RE: Parcel Y - Response to Technical Review Committee Comments

We have reviewed your letter dated October 12th, 2023 and have addressed the items as follows:

Comments prepared by Planning, Jennie Turner

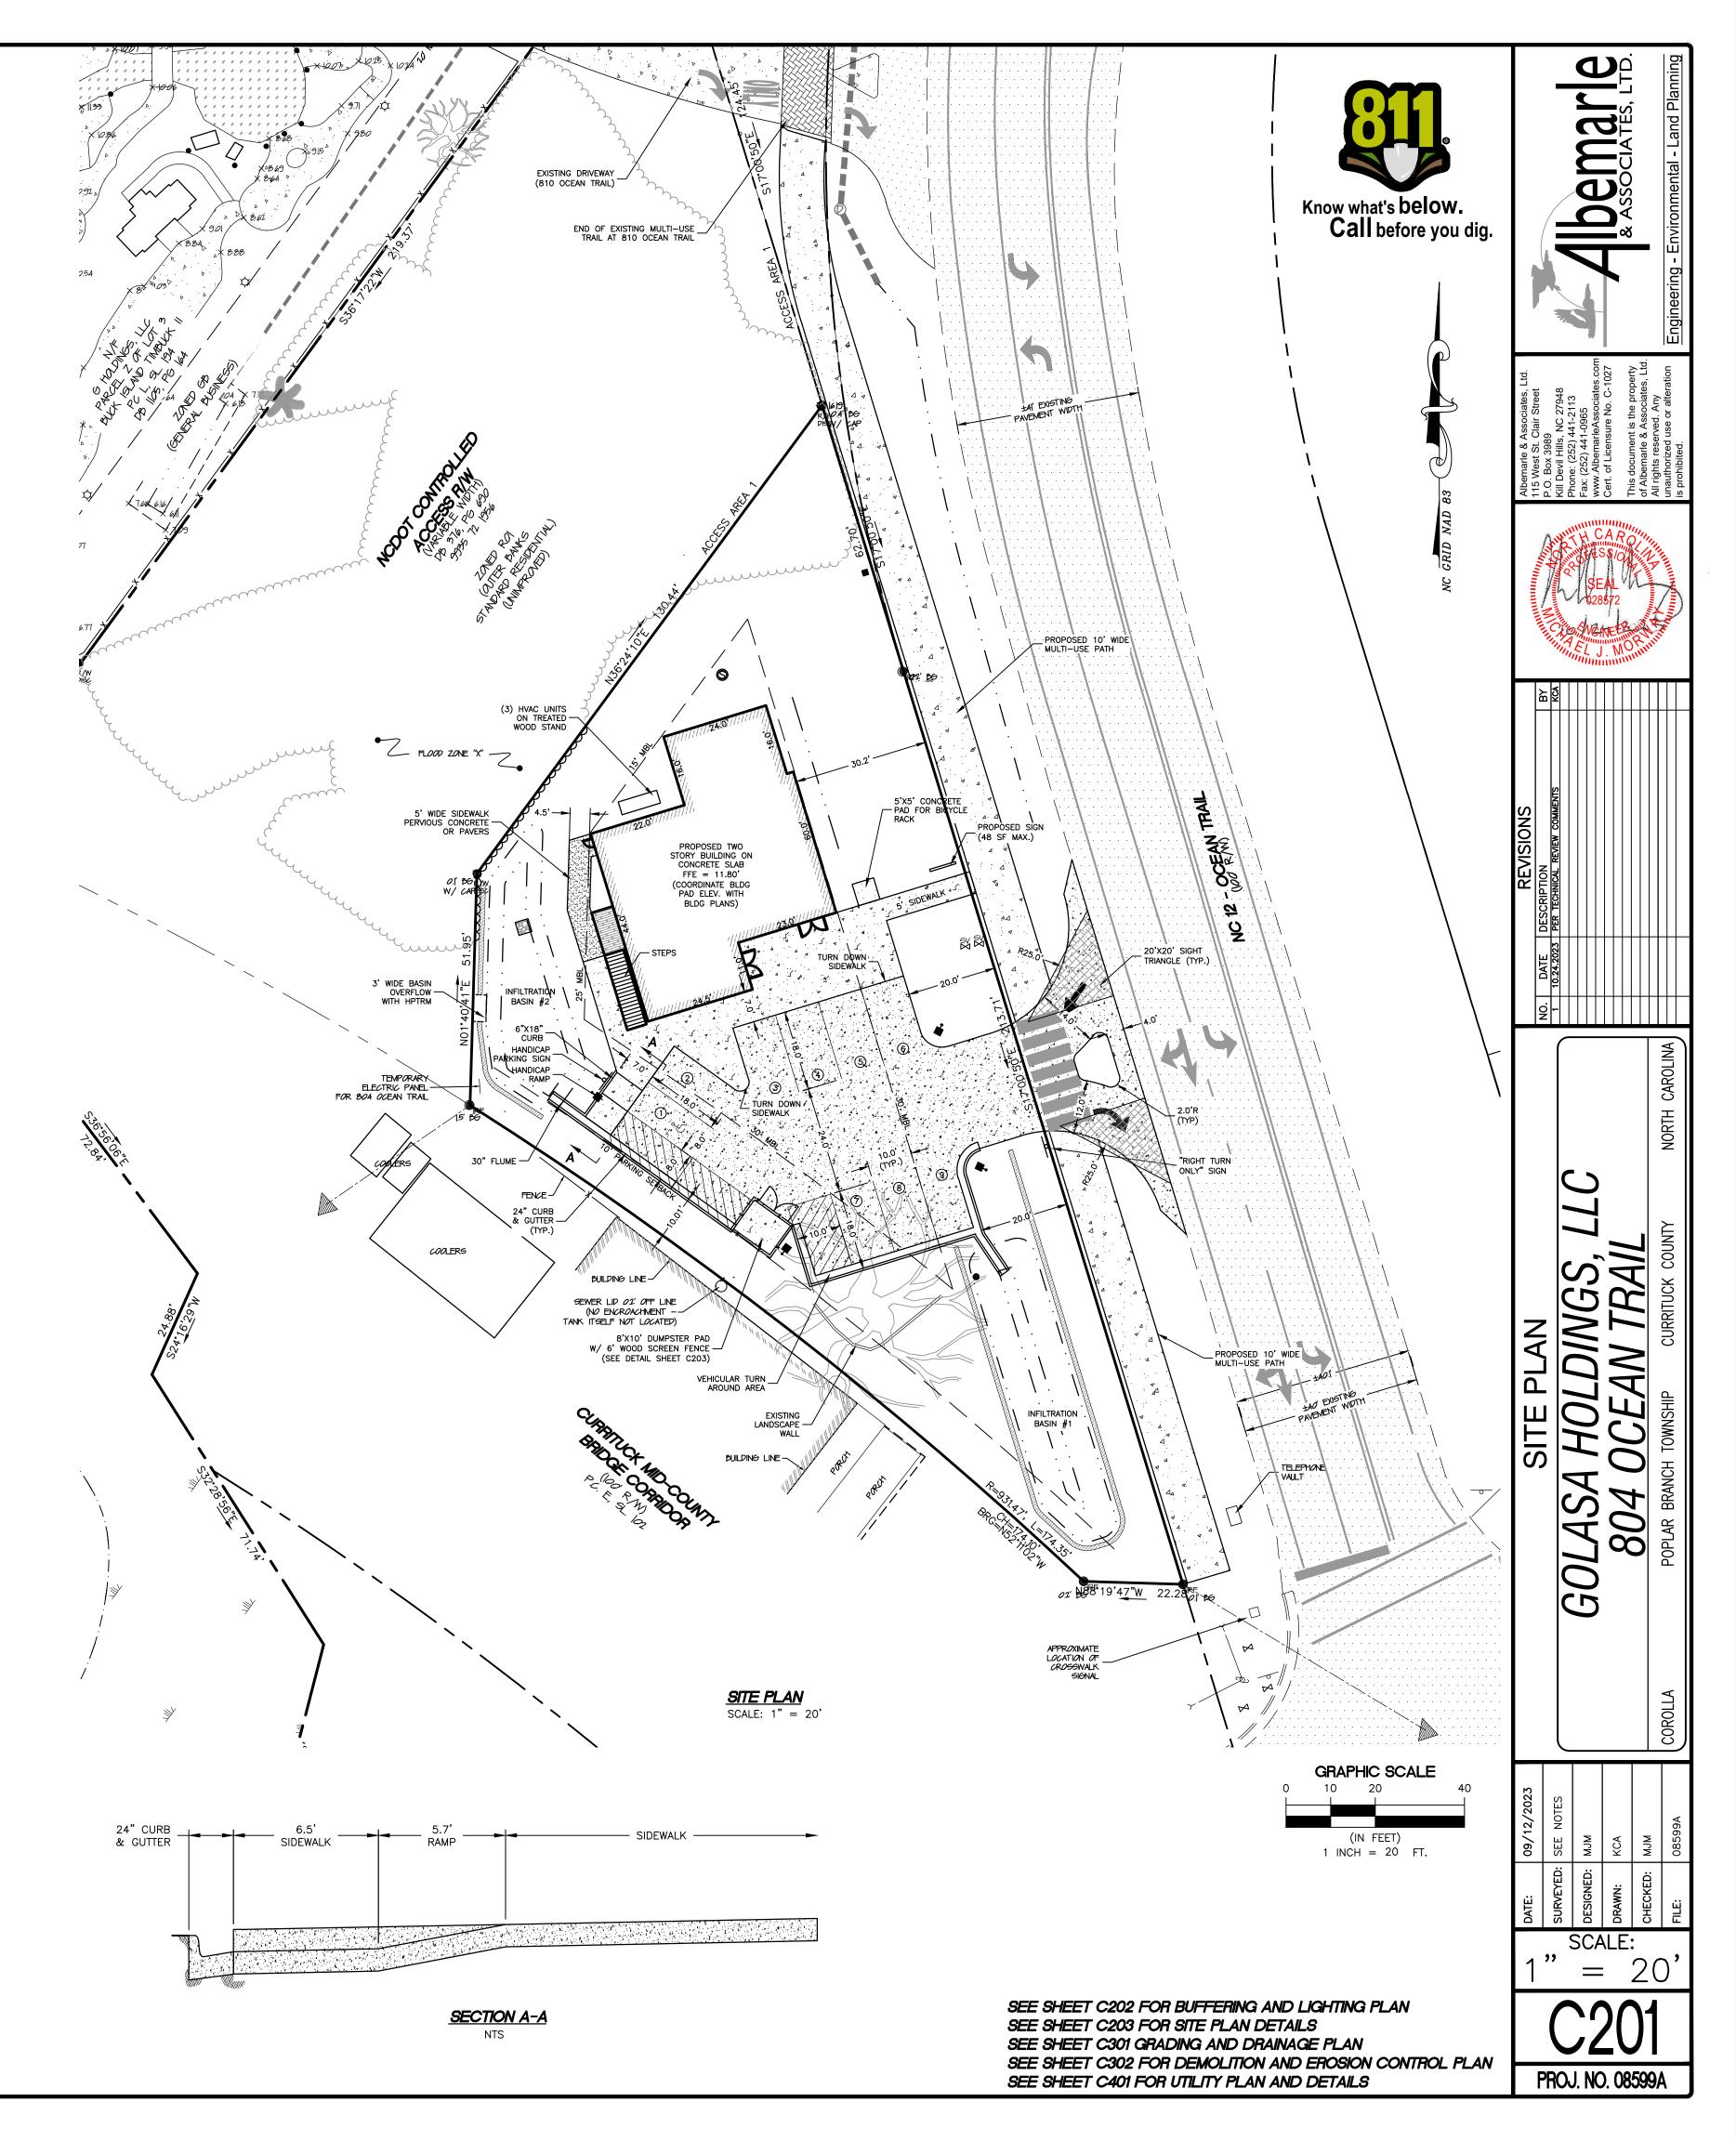
1. The Update plan to include all site addresses provided by GIS.

15. Please amend note #9: 2 upper story dwellings are permitted subject to the amended sketch plan for Buck Island.

21. Please label existing retaining wall around live oak.

Response: Note #3 on sheet C201 has been updated with the addresses indicated by Harry Lee.

Response: Note #9 on sheet C201 has been amended as requested

Response: The existing retaining wall has been labeled on sheet C201.

LIGHTING PHOTOMETRIC PLAN

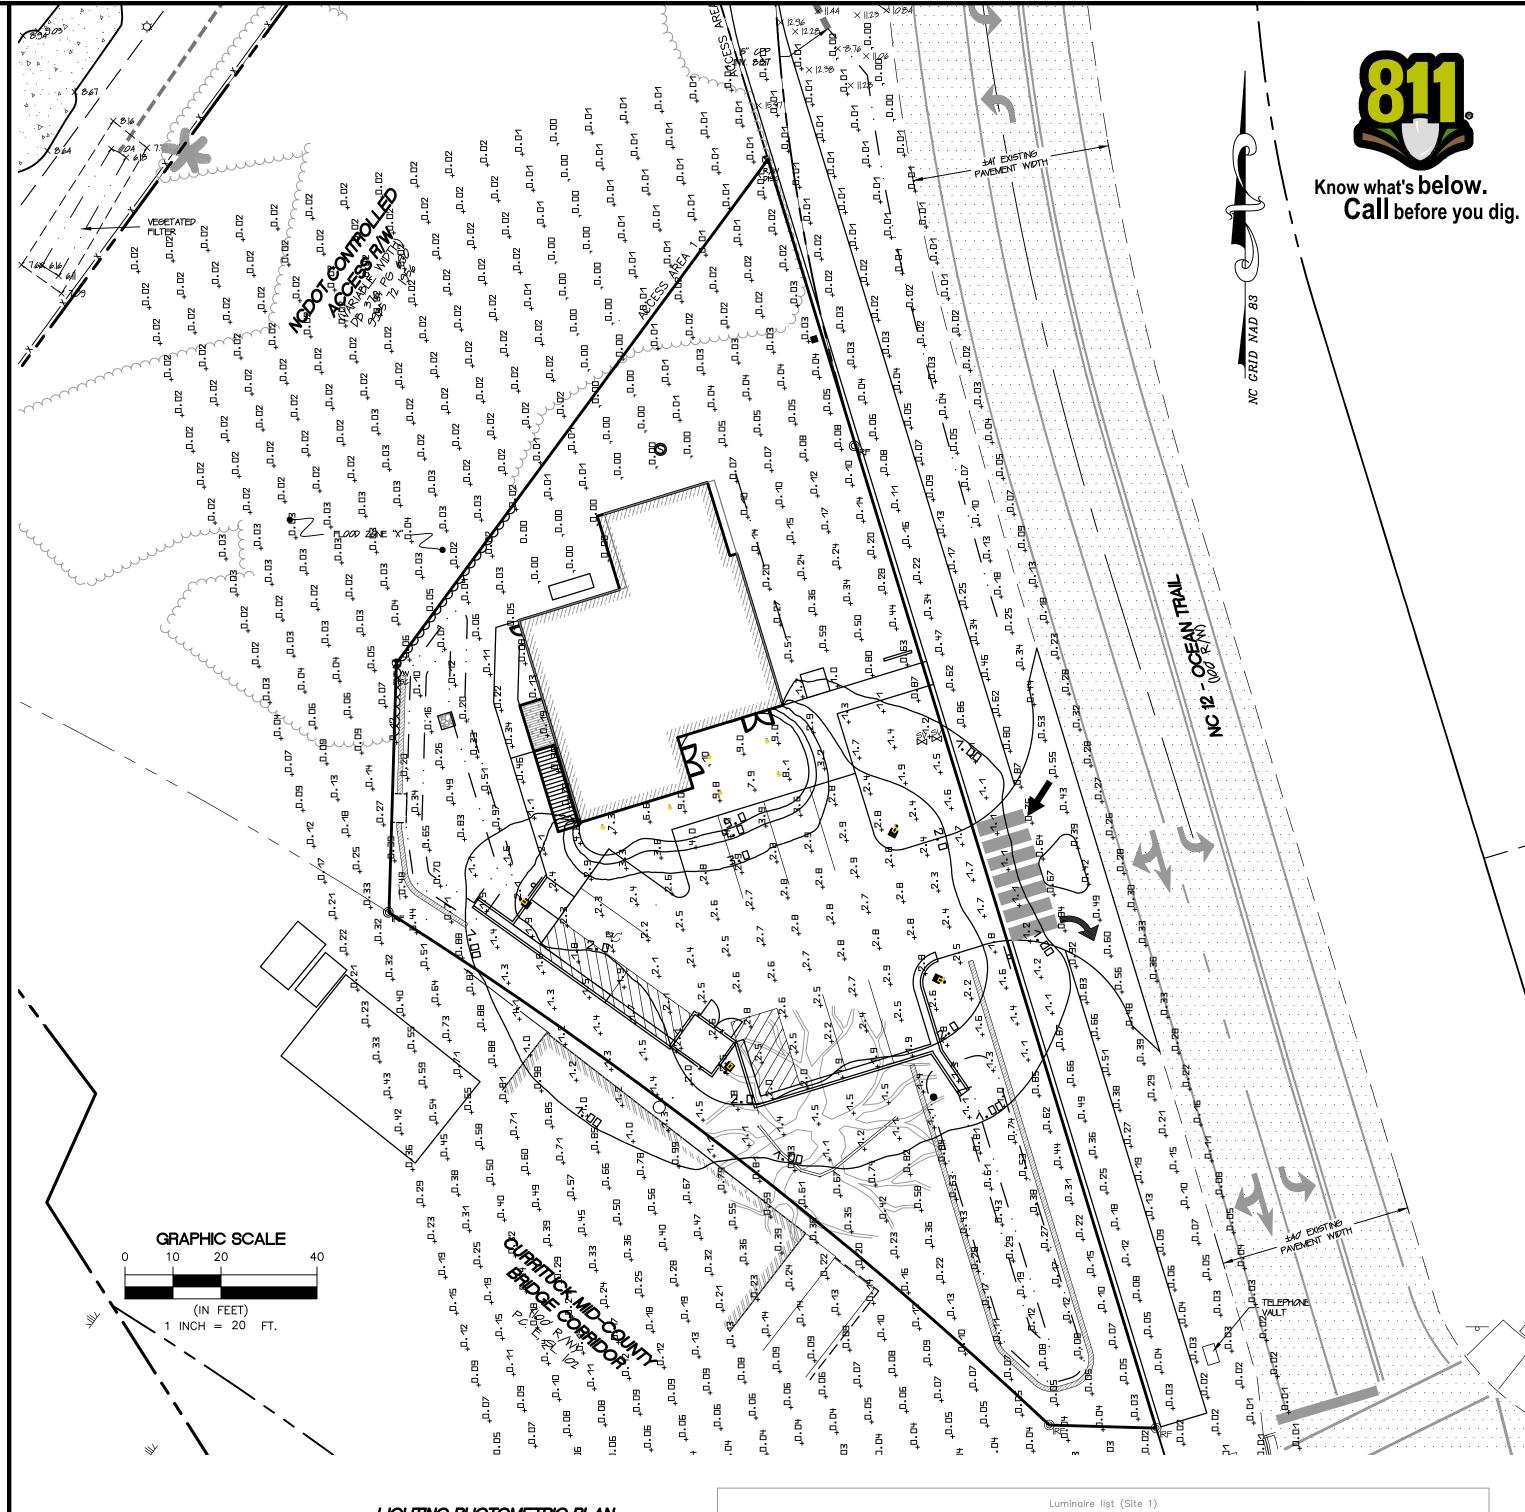
9. Please note vehicular landscaping plants in a similar manner to the other shrubs and trees noted on the plan.

10. Please check landscaping plants provided. ex: building façade shrubs, 12 are noted 10 are shown. Please show all proposed plantings.

11. Please show all proposed plantings.

Response: Symbols have been added to the vehicular landscaping buffer.

Response: Two additional plants have been added to the building façade.

Response: All intended plant locations have been shown on C202.

SCREENED FENCE DETAIL

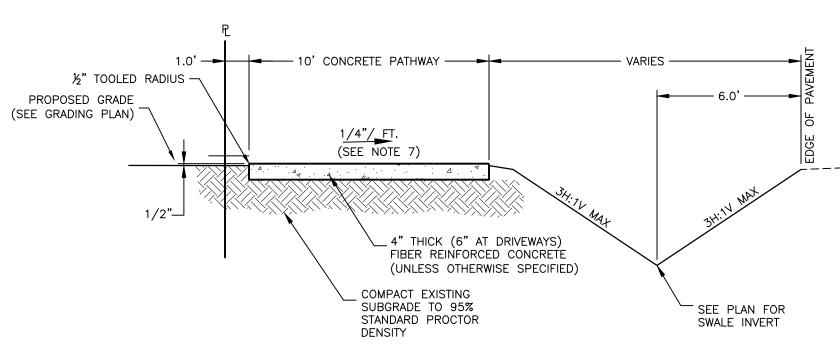
3. How will the proposed dumpster location be accessible to large trash vehicle? Dumpster must be screened on all sides. Dumpster screening must be opaque.

Response: The dumpster location has been sited to allow for a front load waste collection truck dumpster from an angle after pulling into the parking lot. The dumpster pad has a wood screen fence (detail on sheet C203) surrounding it and a gate has been added to the front.

5 East Elevation 1/8" = 1'-0"

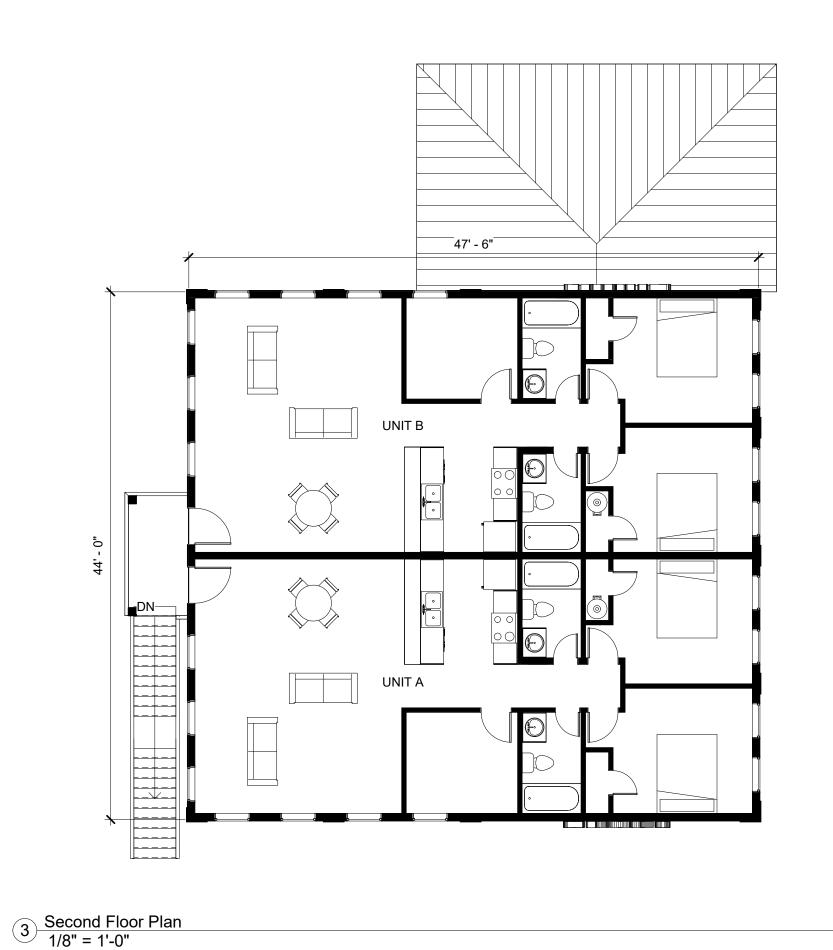
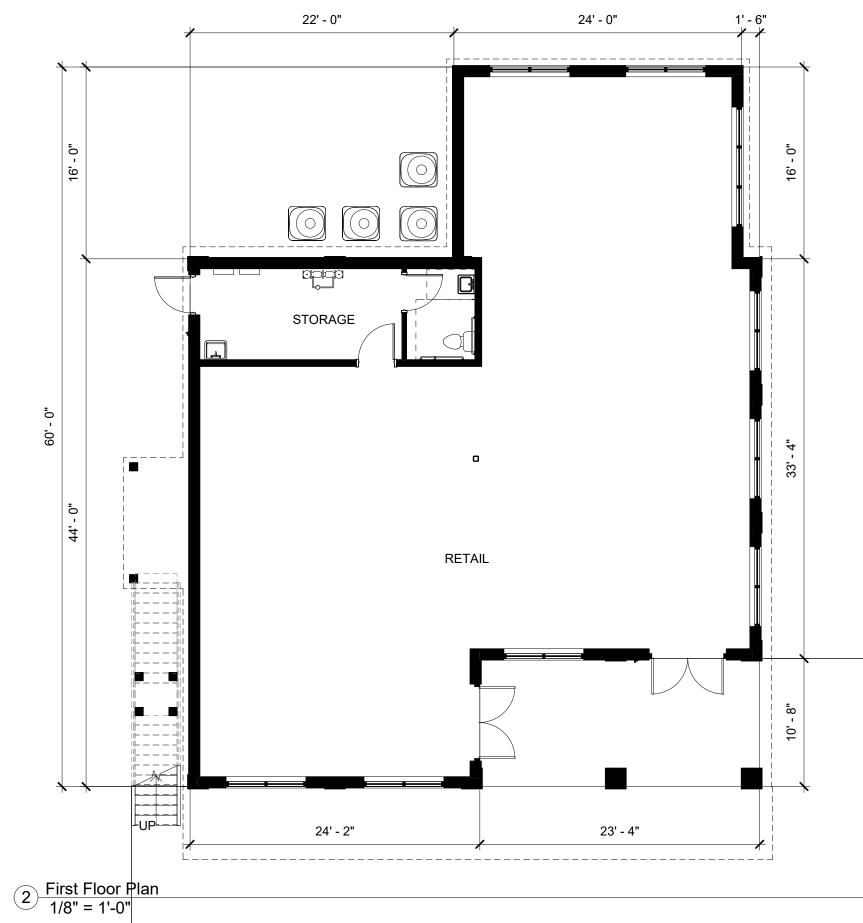
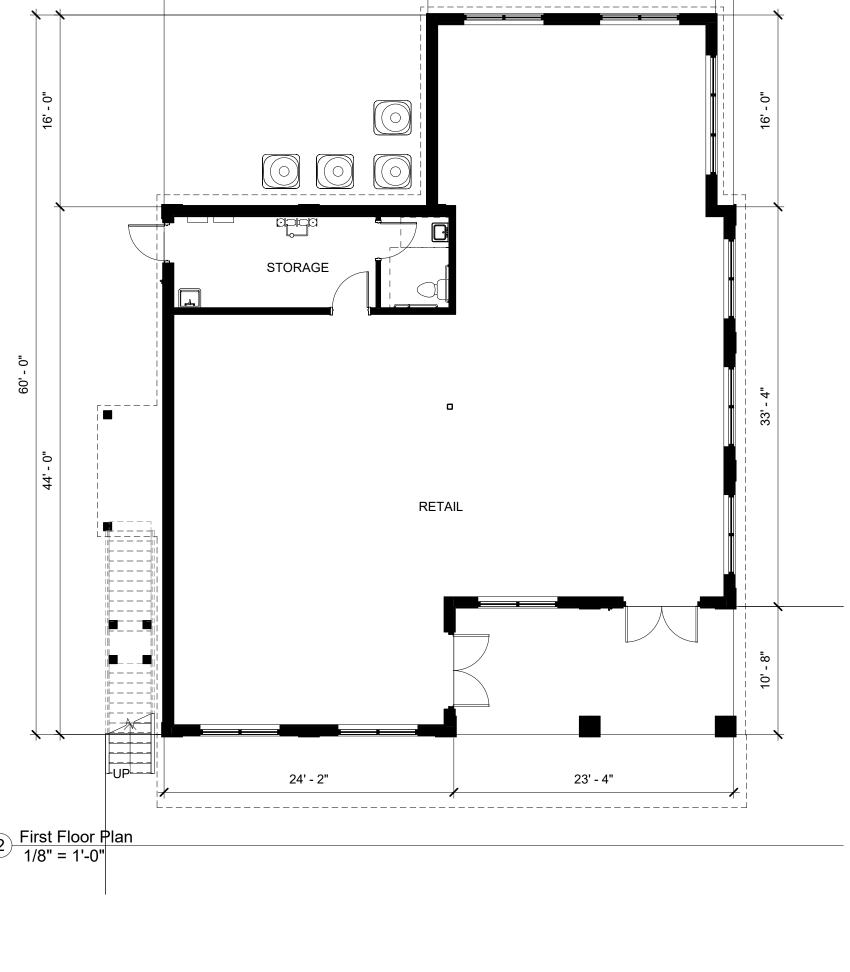
13. Describe specifically the three features from UDO Section 5.8.3.C that are proposed and met with architectural design for each elevation visible from NC12: North, East & South.

I believe since the north and south elevations are less that 50', they are not required to meet Section 5.8.3.C.

The east façade meets the following three sections:

a) The use of projections or recesses in the building façade wall with a depth of 18 inches from the primary façade plane and a minimum width of 10 feet;

The north store portion of the building has been setback 18" to meet this requirement.

b) Façade color changes following the same dimensional standards as the offset standards in (a) above; Building color changes meeting (b) are indicated on the revised drawing.

c) Roofline changes, coupled with correspondingly aligned wall offset facade material changes, including changes in the roof planes or changes in the height of a parapet wall (such as extending the top of pilasters above the top of the parapet wall);

This change is met as the building changes from one story to two story.
